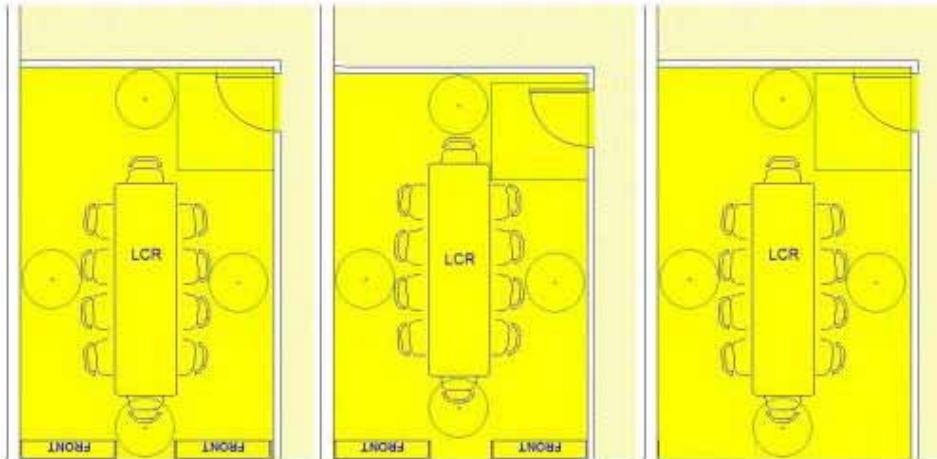
1: Wrong because there is not a clear 36" path between two furniture elements. If there were no bookshelves in this scenario (edge of shelves were where wall would be) then it would be acceptable. See example below

2: Correct because clear 36" path all around.

3: Correct because there is a clear 36" path around table and directly to the Southern most chair. See flow diagram on next page.

4: Wrong because there is not a continuous 36" path to the Southern most chair.

5: Correct because there is a clear 36" path around table and directly to the Southern most chair. See flow diagram on next page.

6: Correct because there is a clear 36" path around table and directly to the Southern most chair. See flow diagram on next page.

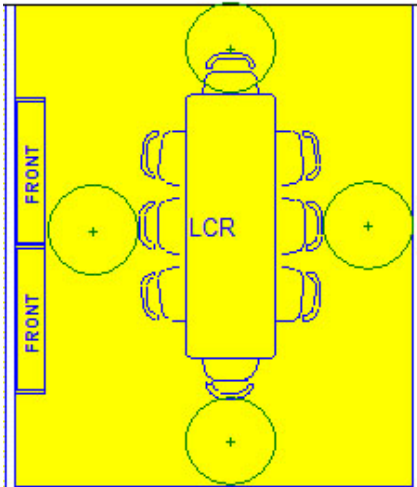
LEFT: Acceptable since there is a clear path around the table of 36" and the southern table is accessible via 36" path unobstructed. See flow diagram next page

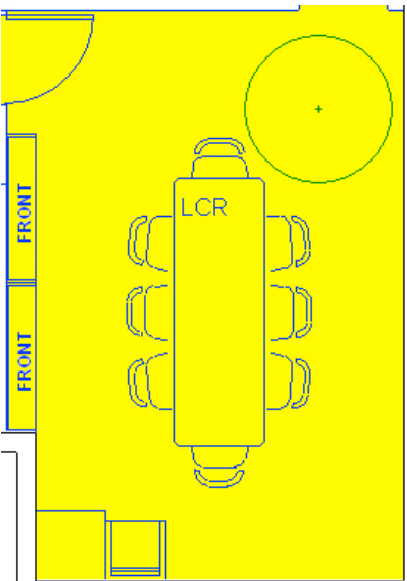
RIGHT: See comments for #6 above
